TOWNSITE OF SEMMES SUBDIVISION, BLOCK 1,
RESUBDIVISION OF AND ADDITION TO LOTS 20, 21,
22, AND A PORTION OF LOTS 23 AND 24

APPLICATION NUMBER 20 DATE February 21, 2008

DETAIL SITE PLAN

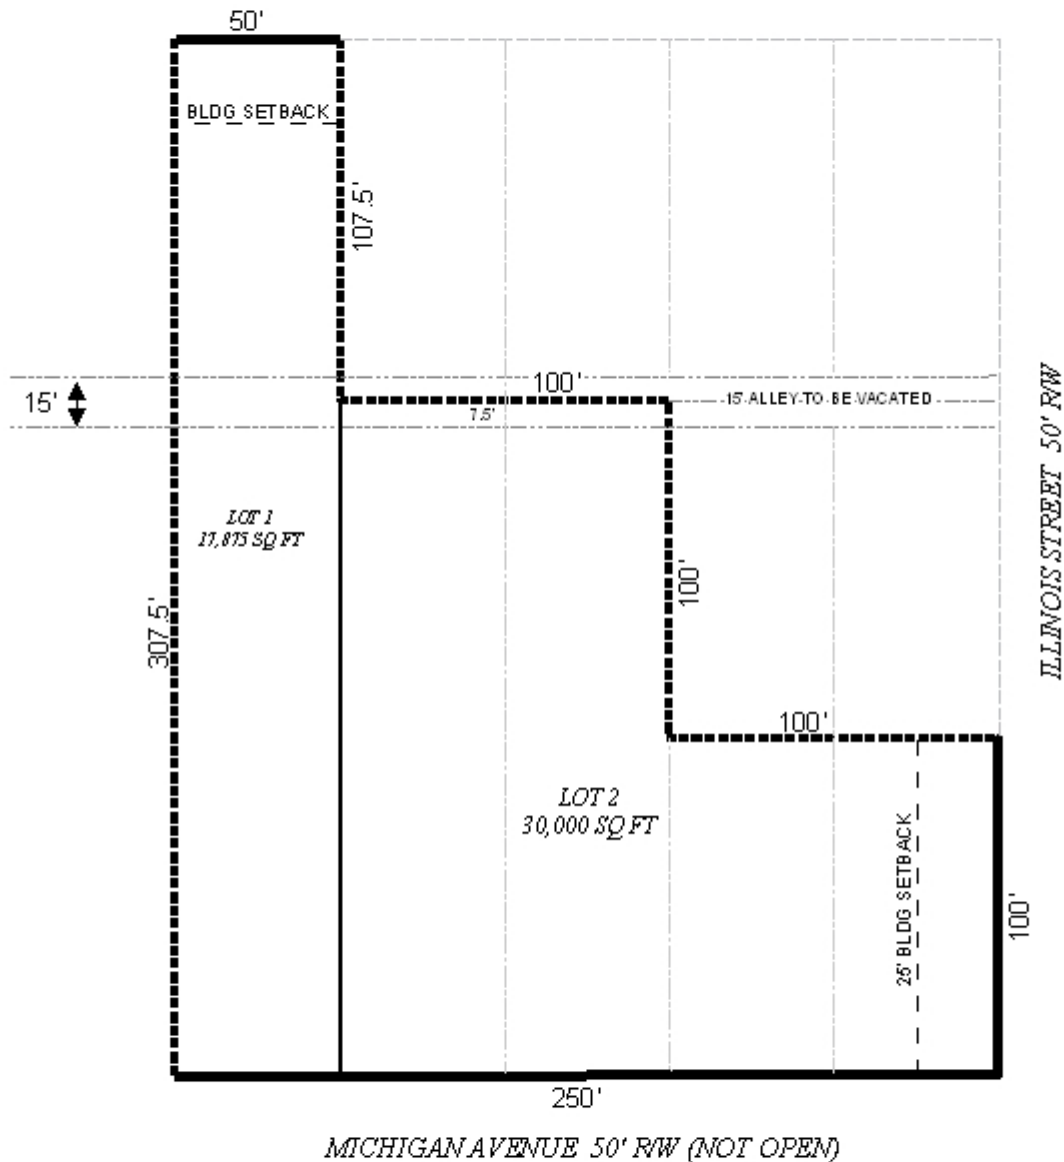
The site fronts on Church Street and Illinois Street, both with adequate right of way; therefore, no dedication is required. The plat indicates the 25' minimum building setback line along Illinois Street and Church Street, and this should also be indicated on the final plat. As a means of access management, Lot 1 should be limited to one curb cut to Church Street, and Lot 2 should be limited to one curb cut to Illinois Street, with the size, design and location of all curb cuts to be approved by County Engineering and conform to AASHTO standards. Since both lots front along Michigan Avenue, an unopened public right-of-way, both lots should be denied access to Michigan Avenue until such time it is constructed to County standards. Upon the construction of Michigan Avenue to County standards, Lot 1 should be limited to one curb cut to Michigan Avenue, and Lot 2 should be limited to two curb cuts to Michigan Avenue, with the size, design and location of all curb cuts to be approved by County Engineering and conform to AASHTO standards.

Each lot is labeled on the plat with its size in square feet. This should also be depicted on the final plat, or a table should be furnished providing the same information.

The plat indicates a public alley between the current Lots 5 and 20, and at the North end of the current Lots 21 and 22. As this is proposed to be vacated and made part of the subdivision, the Vacation process should be completed prior to the signing and recording of the final plat. Also,

since the alley is of substandard width according to the Subdivision Regulations, Lots 1 and 2 should be denied access to the alley.

Lot 1 would exceed the maximum depth-to-width ratio of the Subdivision Regulations. However, since the current Lot 20 has no frontage on an open public right-of-way, combining it with the current Lot 5 to create the proposed Lot 1 would then afford access to Church Street. Also, deep, wide lots are not uncommon of the area. A waiver of Section V.D.3. of the Subdivision Regulations would be in order.

It appears that the applicant sold the Northern portion of Lots 23 and 24 via a metes-and-bounds parceling in 2004; therefore, the Northern portion of Lots 23 and 24 should be included in this application as a third lot.

Based on the preceding, this application is recommended for holdover to the meeting of March 20th to allow the applicant to include the Northern portion of Lots 23 and 24 in this application, and revise the subdivision to three lots. Revisions, new mailing labels, and postage should be furnished by March 3rd.
